## Service Bulletin 424

**Model Affected:** MedSystem III™ Multi-Channel Infusion Pump, Model 2860  
**Date:** December 1997  
**Subject:** Logic Board Assembly

## Service Bulletin 431

**Model Affected:** MedSystem III® Multi-Channel Infusion Pump, Model 2866  
**Date:** November 1998  
**Subject:** Release of Model-2866

**Figure 1 - Keypad Installation**

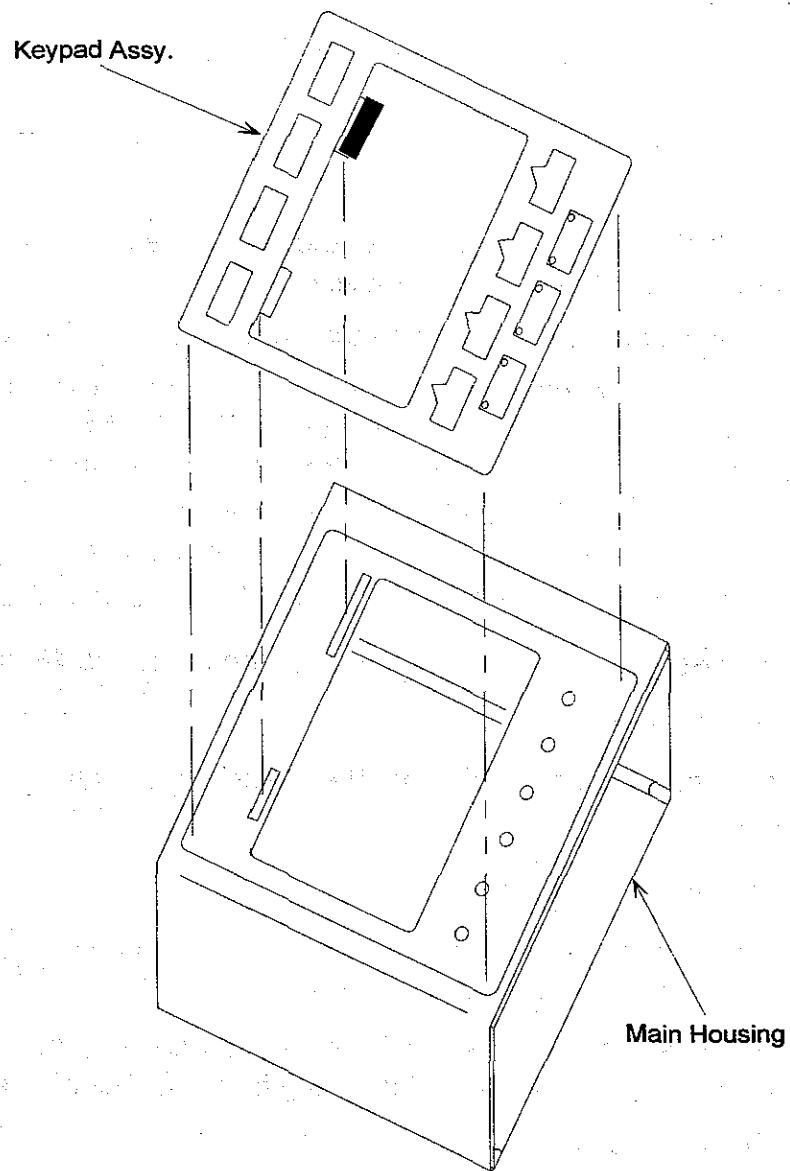
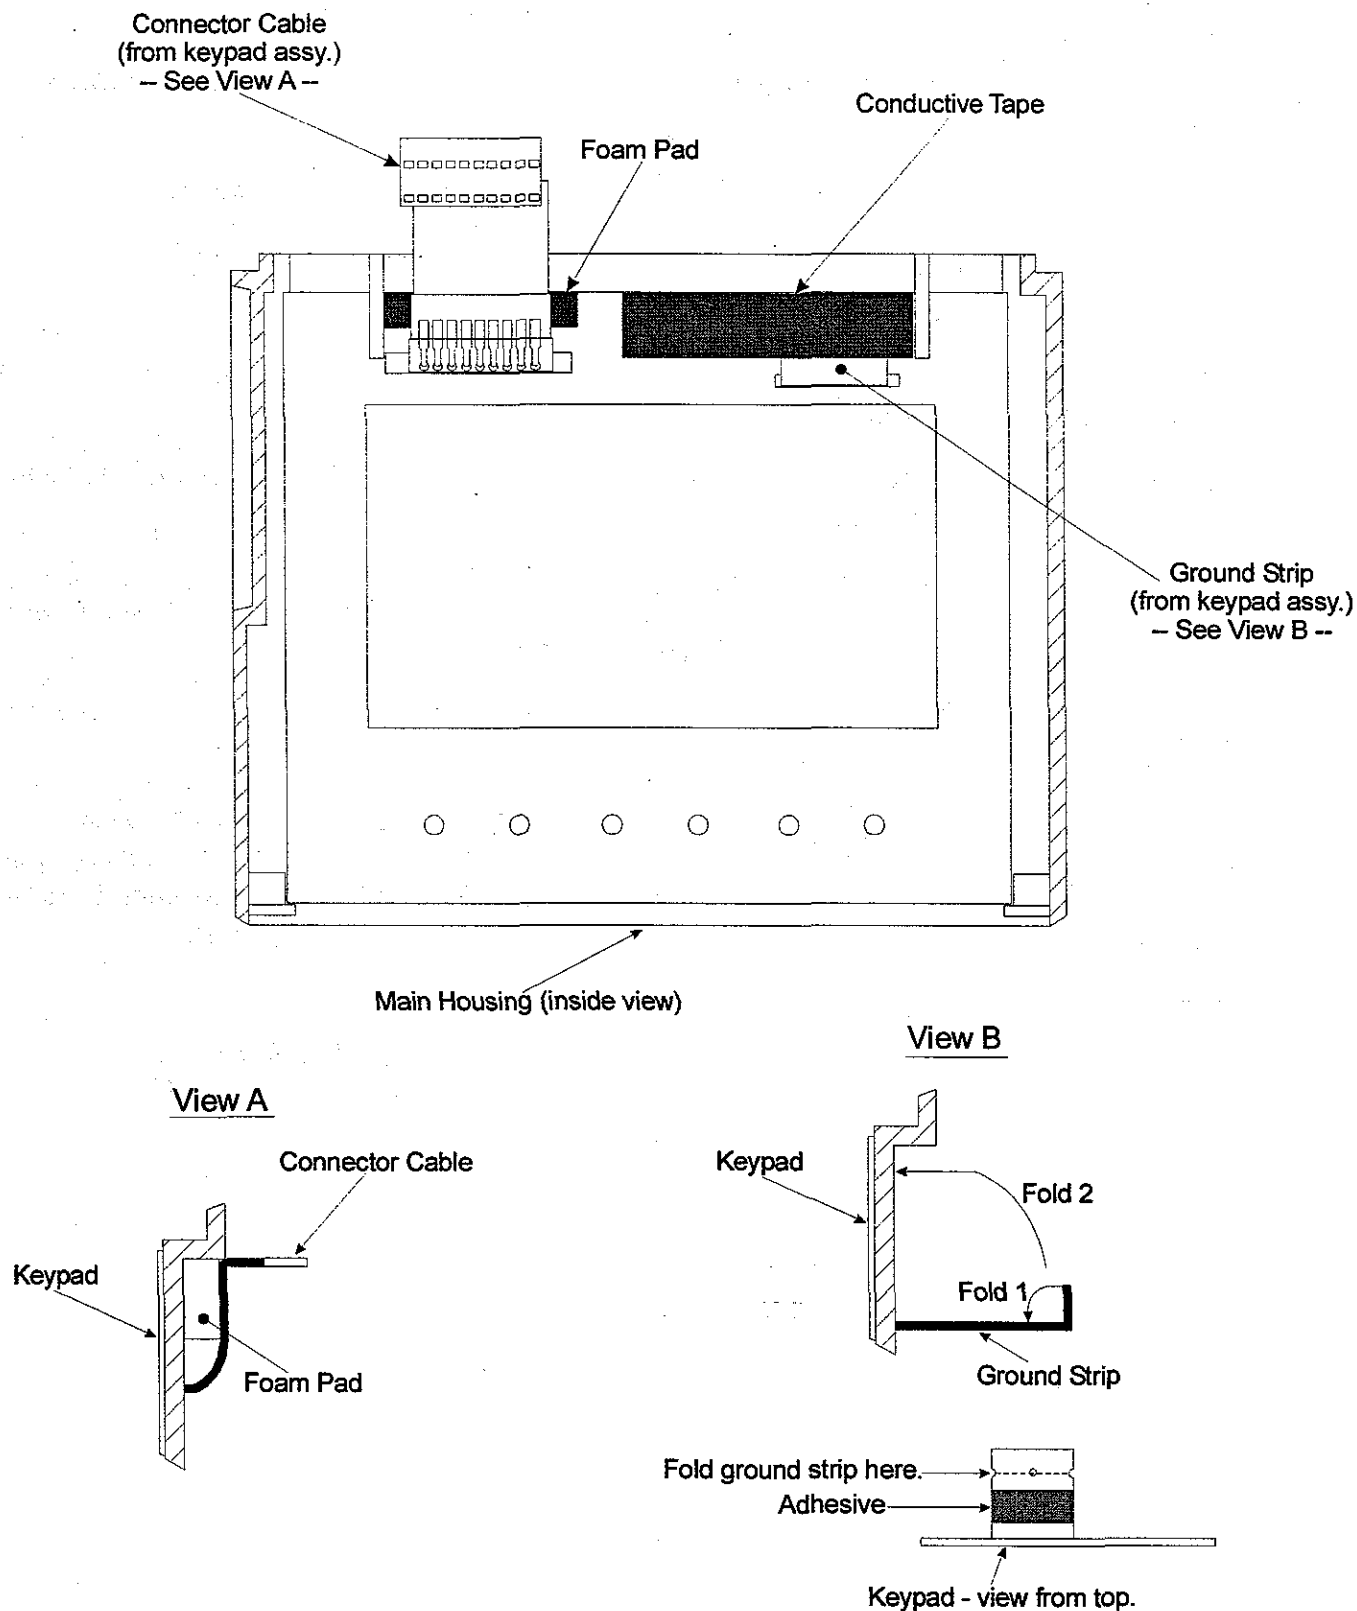
3. Install the new keypad assembly. *(See figures 1 and 2)*
  - a. Remove the protective sheet from the screen of the new keypad assembly.
  - b. Bend the ground strip and connector cable perpendicular to the keypad.

- a. Remove the adhesive backing from the ground strip.
- b. Fold the ground strip, where marked with notches, toward the adhesive strip. *(See view B of figure 2)*

- c. Bend the folded ground strip up and secure it flat against the inside of the main housing. *(See view B of figure 2)*
- d. Apply the conductive tape (provided with the keypad) across the ground strip, aligning the tape just below the top rib of the housing.

- f. Bend the connector cable up and secure it to the foam pad, bending the top portion of the cable to a 90° angle, just below the top rib of the housing. *(See view A of figure 2)*

**Figure 3 - Cable Tie Installation**

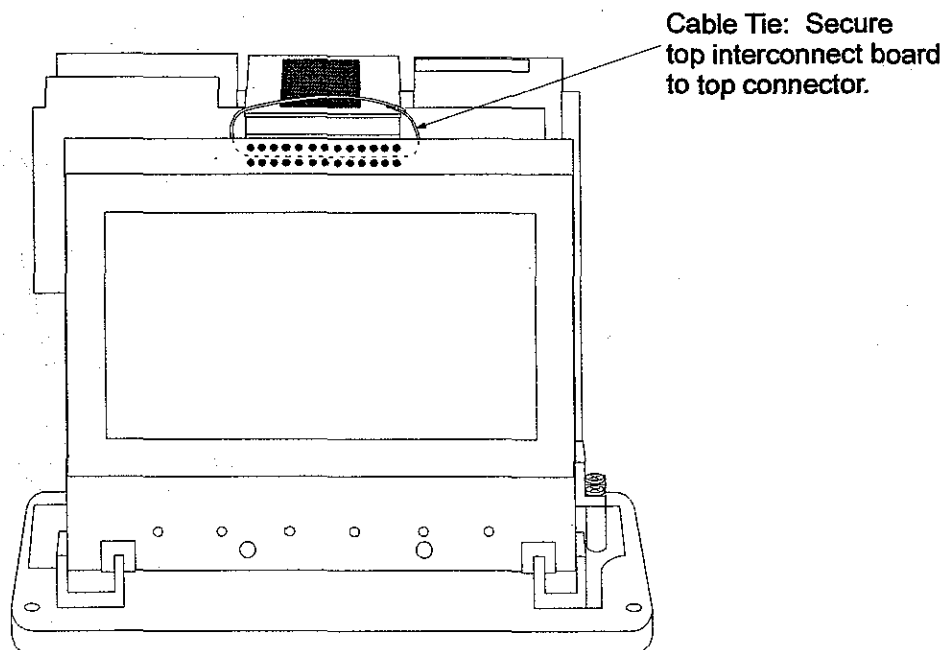
NOTE: As the board assembly is being installed, route the side cable (J1) between the power supply board assembly and the side board assembly, being careful to avoid an interference fit with the ferrite bead on the cable.

3. Install the display module. (Reference *Display Module Reassembly* section in *Repair* chapter of service manual.)
4. Slide a self locking cable tie (reference *Appendix C* in *Appendices* chapter of service manual for *Cable Tie Kit* part number) between the double row header pins of the top connector on the display module, and over the top interconnect board. Tighten the cable to secure the top interconnect board to the top connector of the display module. (See figure 3)

**Figure 4 - Side Board Cable Fold**

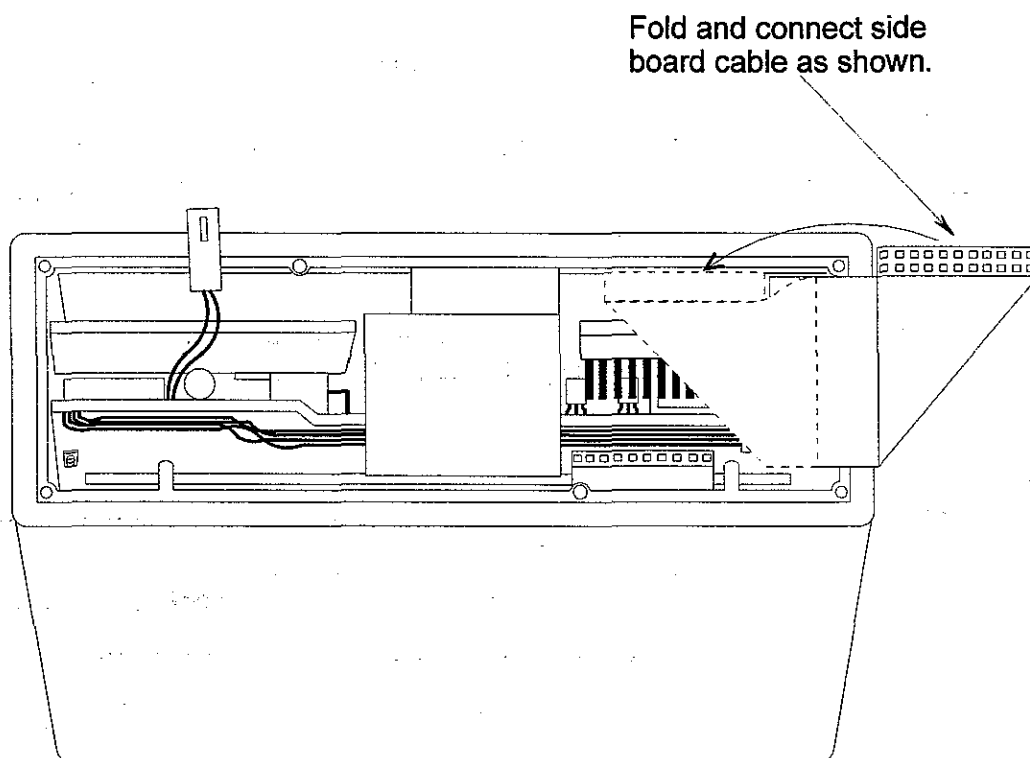
1. Disassemble the instrument and remove the side board assembly per the *Audio/Connector PCBA and Label Replacement* section in the *Repair* chapter of the service manual.
  2. Install the side board assembly per the *Audio/Connector PCBA and Label Replacement* section in the *Repair* chapter of the service manual, with the following differences:
    - a. Place a flat washer (removed during disassembly) on each of the two socket connectors on the new side board assembly.
    - b. Do not seal the gap between the housing and the connectors with silicone sealant.
- NOTE: The use of a flat washer eliminates the need for sealant.
- c. Ensure that the cable is properly folded. (See figure 4)

**Figure 1 - SMT Board Assembly (component location reference)**

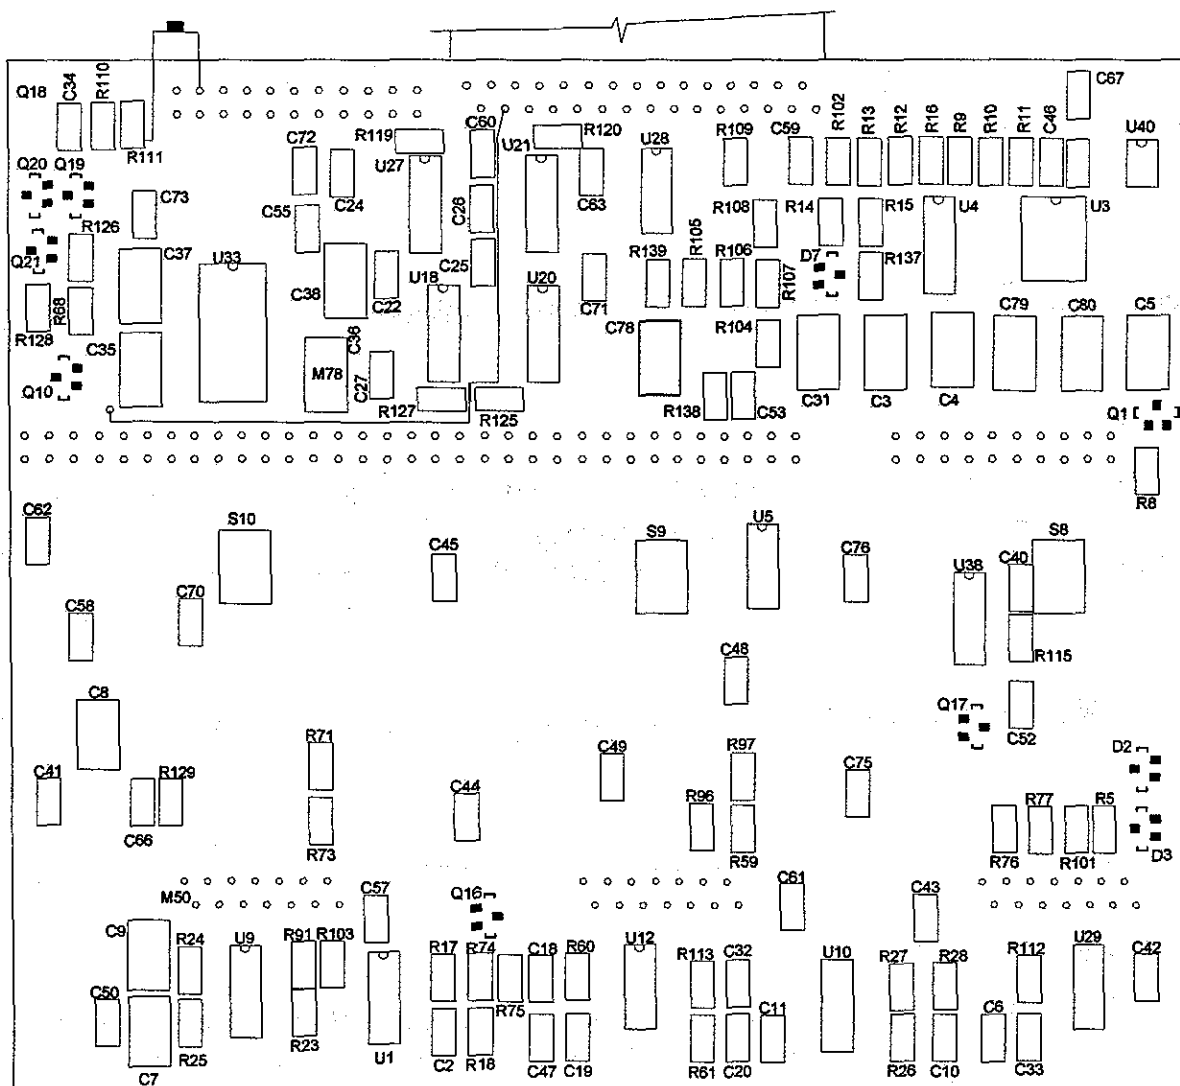
When installing a new LCD display module in a Model 2860, the display may be too dark, even with the contrast adjustment at the lightest setting. This is due to a difference in drive requirements between the latest version of the LCD display and the earlier display.

When a new LCD display module has been installed in a Model 2860 and the display contrast is considered to be too dark, it is recommended that the instrument be returned to ALARIS Medical Systems for modification.

NOTE: If the board assembly has been modified to address a dark display problem, R15 will be 150 ohms and R137 will be 8.2K ohms
